April 25, 2018

Attachment 1

RE: Art Piece Installation and Re-Alignment of CES7 Water Aerodrome Departure Airway

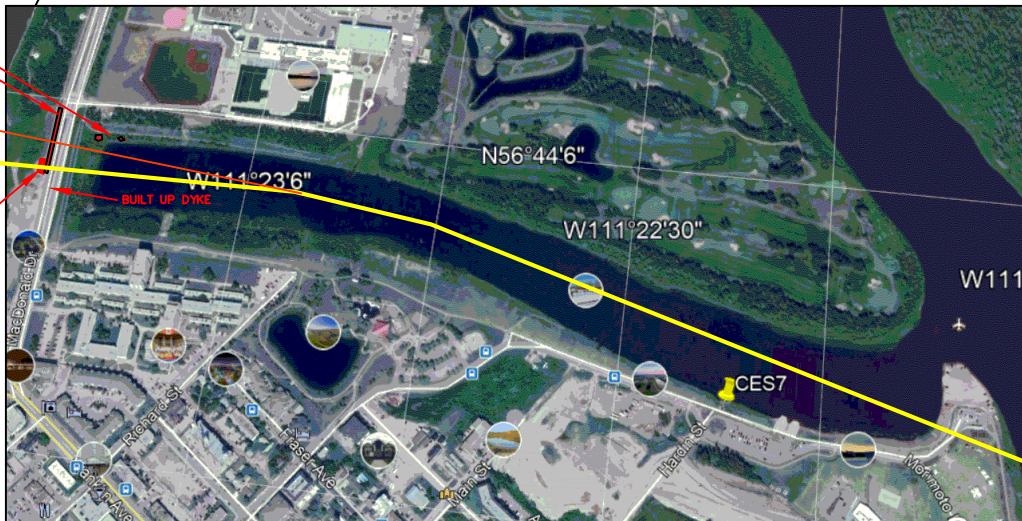
The installation of a 20' - 23' elevated art piece at MacDonald Drive on the centerline of CES7's departure airway will require an initiative to ensure continued aviation safety.

Whereas the placement of the "Reflections on the River Public Art Piece" has potential to impact the safety of aircraft in an emergency descent, the centerline of departure airway will have to be offset to the north.

To facilitate the new centerline of the departure airway and maintain aviation safety, a number of trees will have to be removed along the sides of MacDonald Drive. The trees lying on the westerly side of MacDonald Drive from the proposed art installation location to the Total Trail in addition to two groups of Aspen at the north west corner of the Snye will have to be removed. This is necessary to provide distressed aircraft the greatest amount of unobstructed airway access to the Athabasca River.

TREES TO BE REMOVED
TO AID FLIGHT-PATH SAFETY

REVISED FLIGHT PATH CENTRELINE
